Comments

RE: Comments of Minnkota Power Cooperative, Inc. on the Draft Specific Site Assessment for Coal Combustion Waste Impoundments at Minnkota Power Cooperative Milton R. Young Station, Center, North Dakota (GEI Consultants, Inc., December 2010)

Comments of Minnkota Power Cooperative, Inc. on the Draft Specific Site Assessment for Coal Combustion Waste Impoundments at Minnkota Power Cooperative Milton R. Young Station, Center, North Dakota (GEI Consultants, Inc., December 2010).

Name: Minnkota
 Description: Exterior Slope Analysis - 3:1 Slope
 Method: Spencer
 File Name: Cell3 - slope_analysis_3-1-95 ft-min.gsz
 Date: 2/2/2011
 Slip Surface Option: Grid and Radius
 Minimum Properties

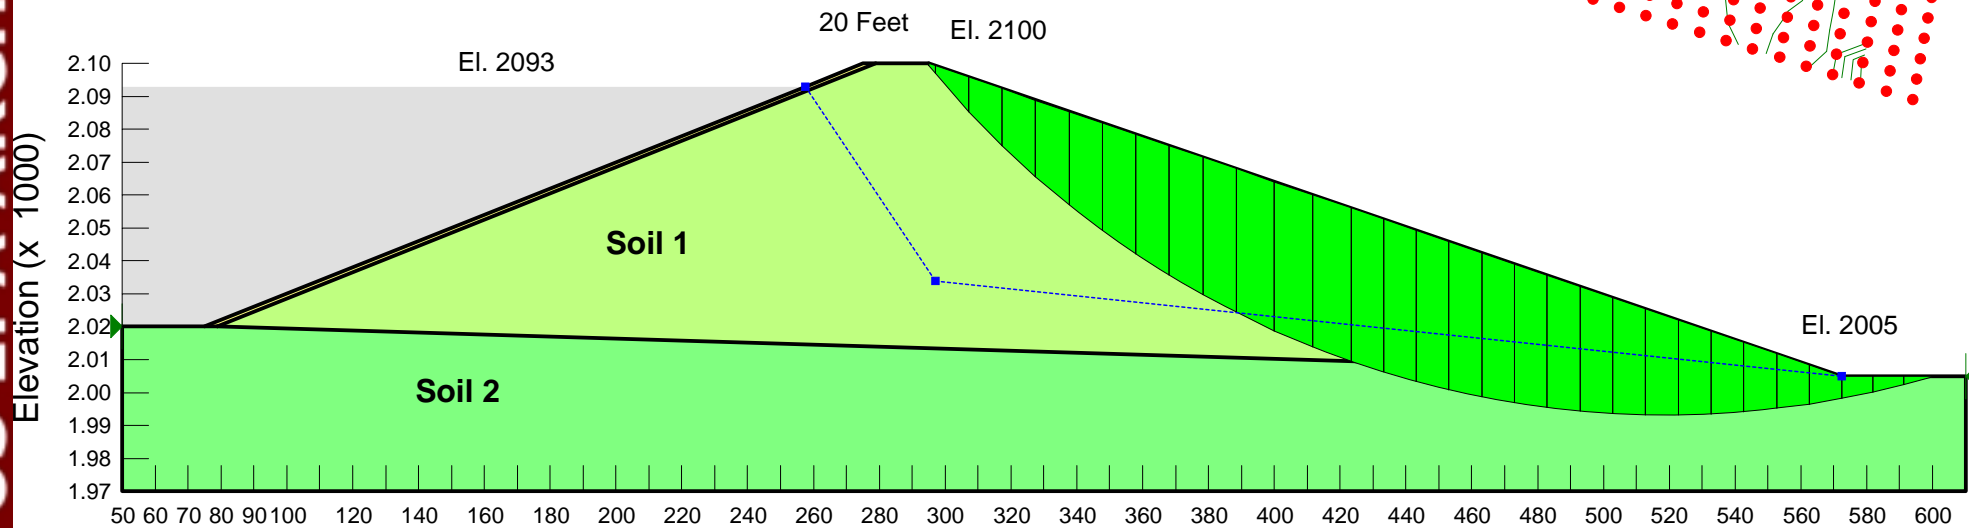
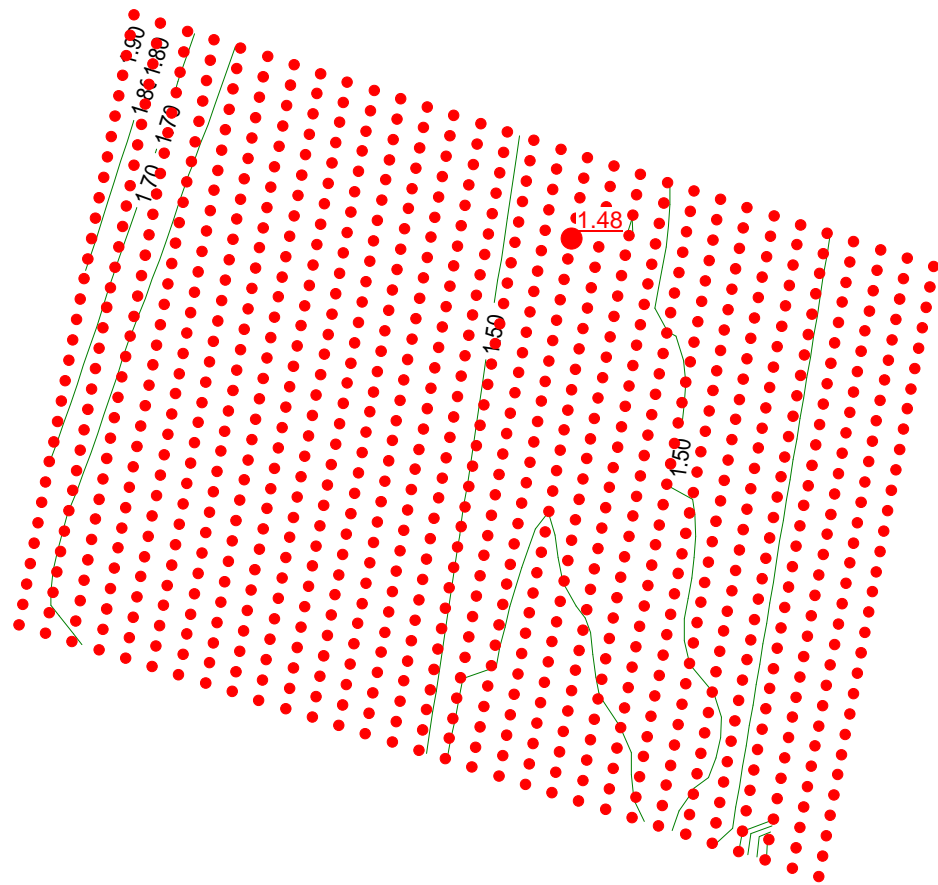
Results of the exterior dike modeling show all cases met a factor of safety greater than 1.5 (Barr, 1994). Similar to the interior dike modeling the exterior models are believed to be conservative given that the native subgrade is anticipated to be stronger and the affects of clay liner are not accounted for in the original modeling.

FOS: 1.48

Name: Minnkota
 Description: Exterior Slope Analysis - 2.5:1 Slope
 Method: Spencer
 File Name: Cell3 - slope_analysis_2-5-1-95 ft-min.gsz
 Date: 2/2/2011
 Slip Surface Option: Grid and Radius
 Minimum Properties

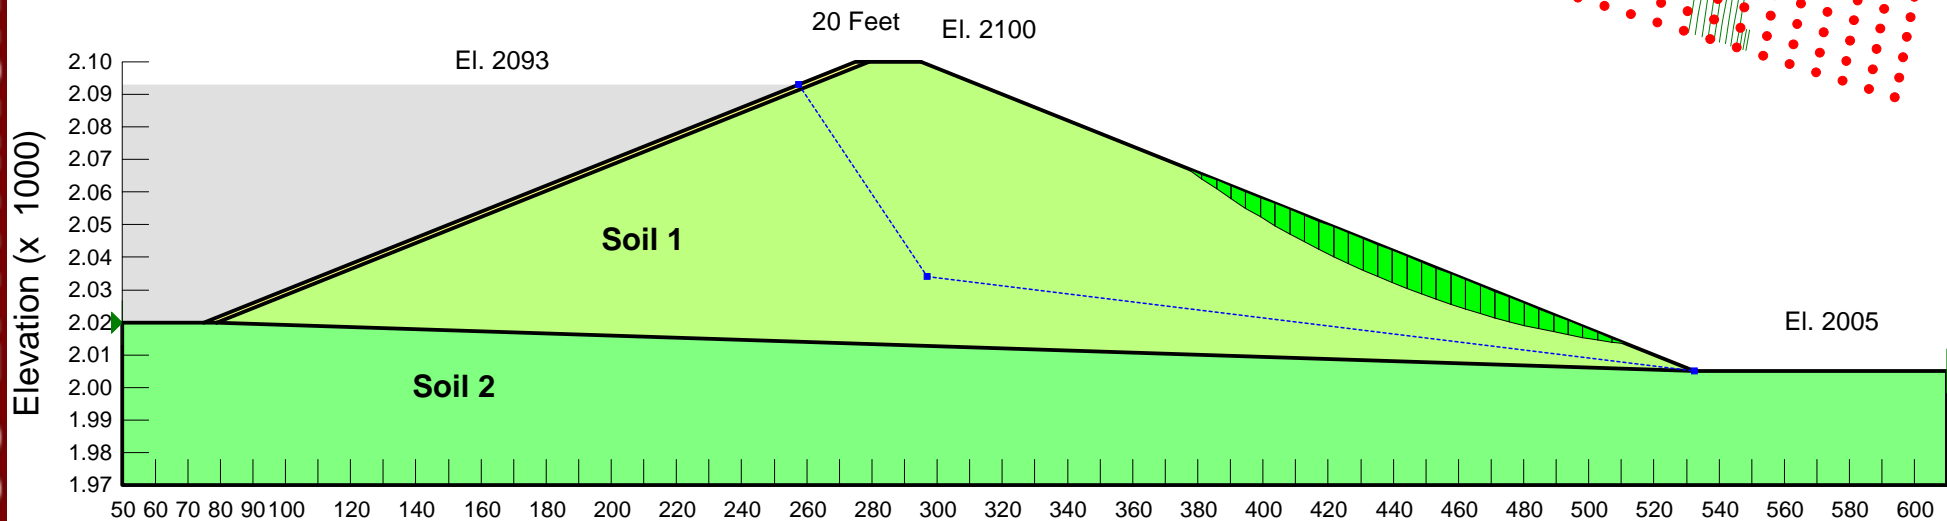
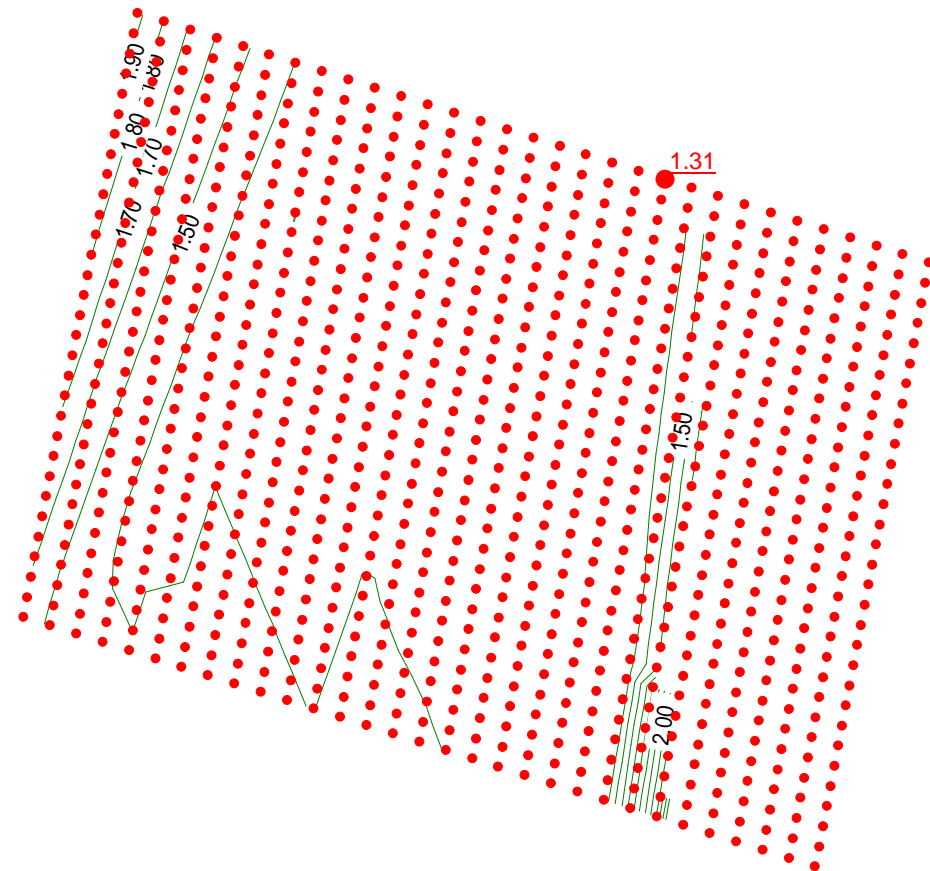
When the 1994 modeled assumptions were modified only to account for the downstream slope, the results indicate that both the average and minimum soil strength values for the 2.5:1 slope with 95 foot high dike exceed the recommended minimum factor of safety value (1.3). However, conditions encountered in the field over the last 17 years do not match the “minimum” or “average” strength values.

FOS: 1.31

Name: Minnkota
 Description: Exterior Slope Analysis - 2.5:1 Slope - Estimated Actual Conditions
 Method: Spencer
 File Name: Cell3 - slope_analysis_2-1-1-95 ft-actual_cond.gsz
 Date: 2/4/2011
 Slip Surface Option: Grid and Radius
 Minimum Properties

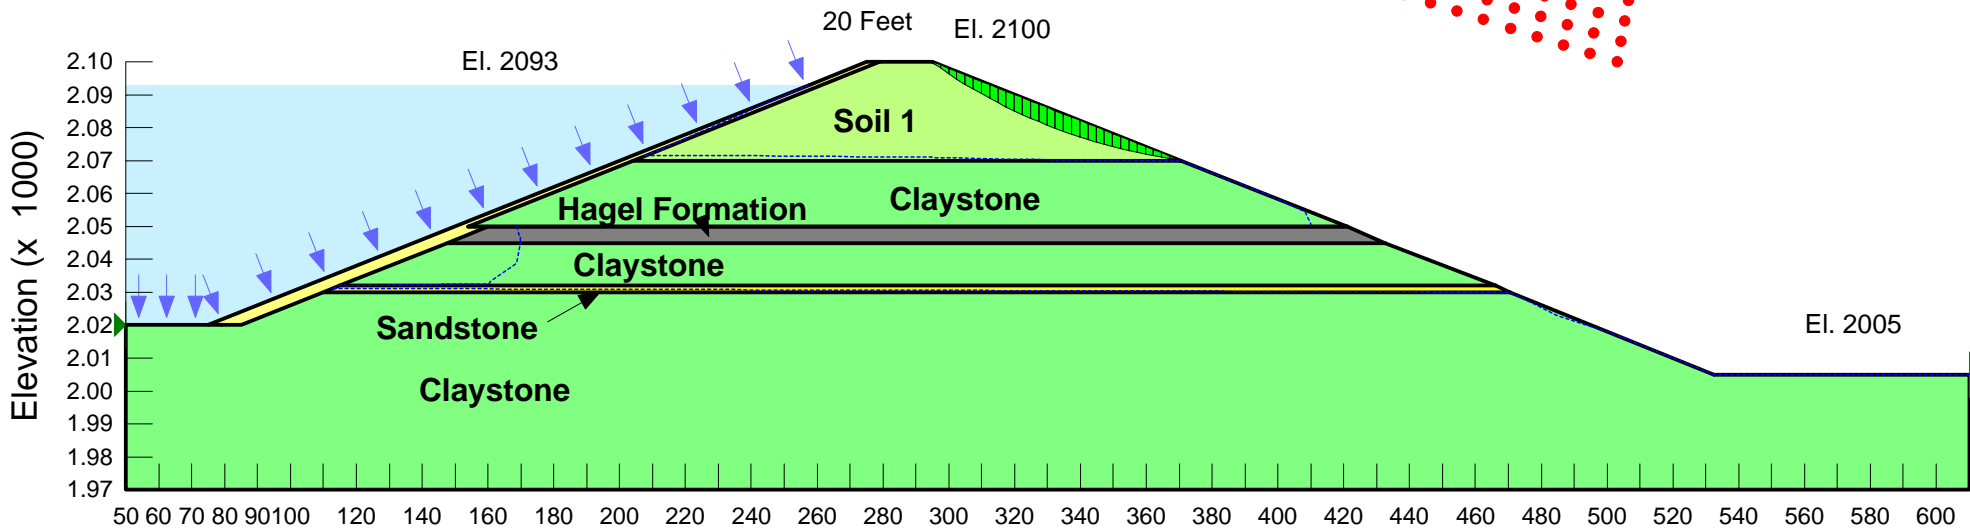
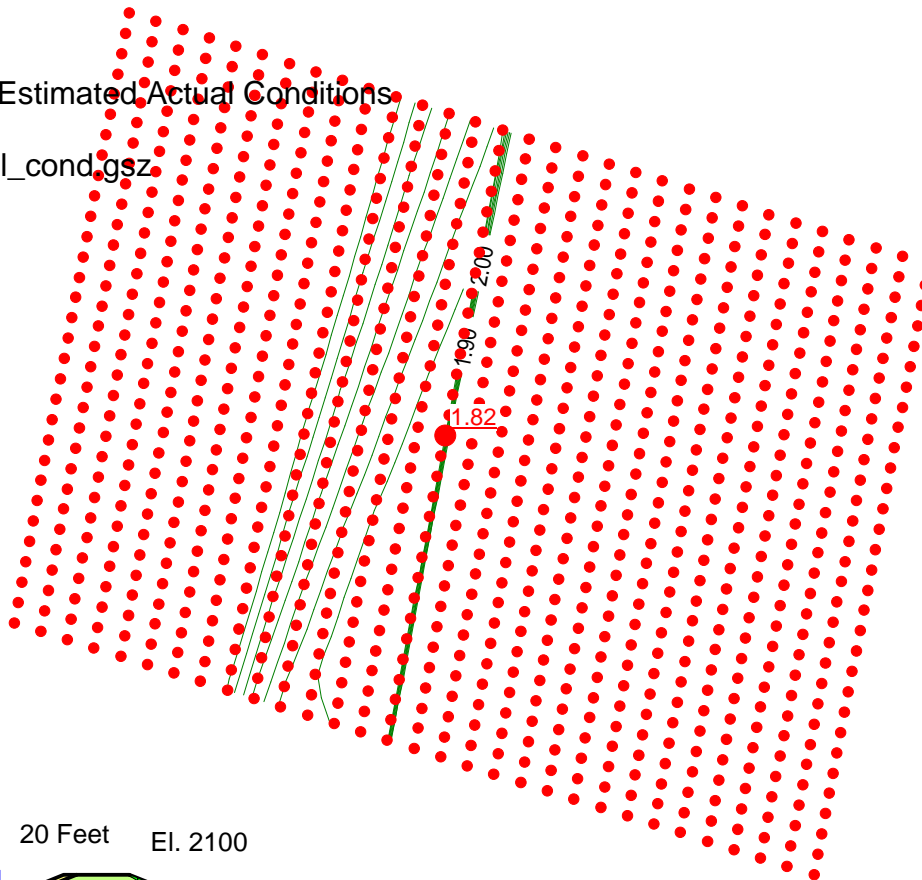
The model was also updated to provide results that more closely depict actual conditions. Actual conditions include: an embankment composed of placed fill, claystone, Hagel formation, and sandstone. Layer thicknesses and contact elevations are based on topography and boring logs (Barr, 2010). Additionally, hydraulic conductivity was included in the stability model using Seep/W. The phreatic surface determined from seepage modeling was imported into the stability model (The model conservatively assumes the cells will not be dewatered, thus, a phreatic surface will occur in the embankment). Stability models were performed for a 3:1 slope and a 2.5:1 slope, both with a dike height of 95 feet. Table 5 presents the resulting factor of safety values for the actual conditions.

FOS: 1.82
